Access Compliance Report

Public Rights-of-Way

Intersection ID: 10036867	Main Street: S_KINGS_DR	Cross Street: N/A	Location: N
ADA ID: BB7EE6177641	Ramp Type: PerpDiag	Initial Pass/Fail: Fail	Overall Compliance: No
		Severity Score: 37.5

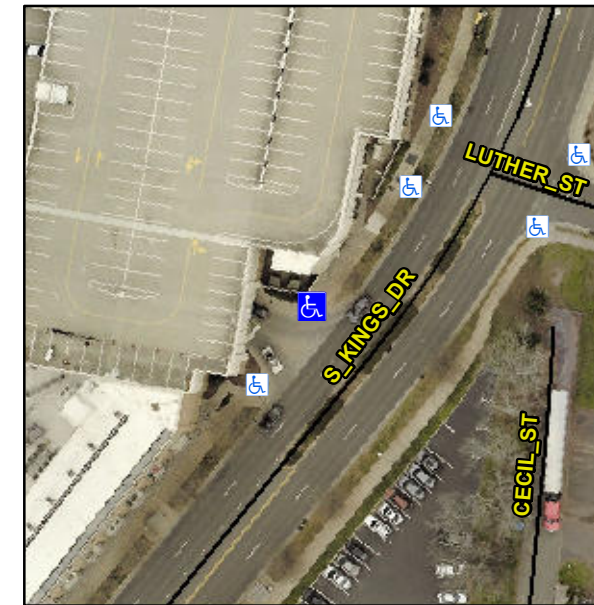
Not Found, R304.2.2, R304.5.3

Compliance	Description	Data	Compliance	Description	Data
N/A	Ramp Length (in)	77.0	No	Ramp Slope (%)	8.6
Yes	Ramp Width (in)	48.0	No	Ramp XSlope (%)	7.5
N/A	Flare Type LT	N/A	N/A	Flare Type RT	N/A
N/A	Flare Slope LT (%)	N/A	N/A	Flare Slope RT (%)	N/A
N/A	Flare Traversable LT?	N/A	N/A	Flare Traversable RT?	N/A
N/A	Landing Length (in)	N/A	N/A	DWS Provided?	N/A
N/A	Landing Width (in)	N/A	N/A	DWS Contrast?	N/A
N/A	Landing Slope (%)	N/A	N/A	DWS Length (in)	N/A
N/A	Landing X Slope (%)	N/A	N/A	DWS Full Width?	N/A
N/A	Landing Curb? (Y/N)	N/A	N/A	DWS Offset (in)	N/A
N/A	Shared Landing?	N/A			
N/A	Gutter Ponding?	N/A	N/A	Gutter Slope (%)	N/A
N/A	Gutter Lip Ht (in)	N/A	N/A	Gutter X Slope (%)	N/A
N/A	Painted X Walk1?	No	N/A	Painted X Walk2?	No
	X Walk 1 Direction	To SW		X Walk 2 Direction	To SE
N/A	X Walk 1 Width (in)	N/A	N/A	X Walk 2 Width (in)	N/A
	X Walk 1 Slope (%)	0.1		X Walk 2 Slope (%)	0.3
	X Walk 1 X Slope (%)	0.0		X Walk 2 X Slope (%)	1.1

Remove & Replace Curb Ramp With Two New Directional Ramps or Equivalent.
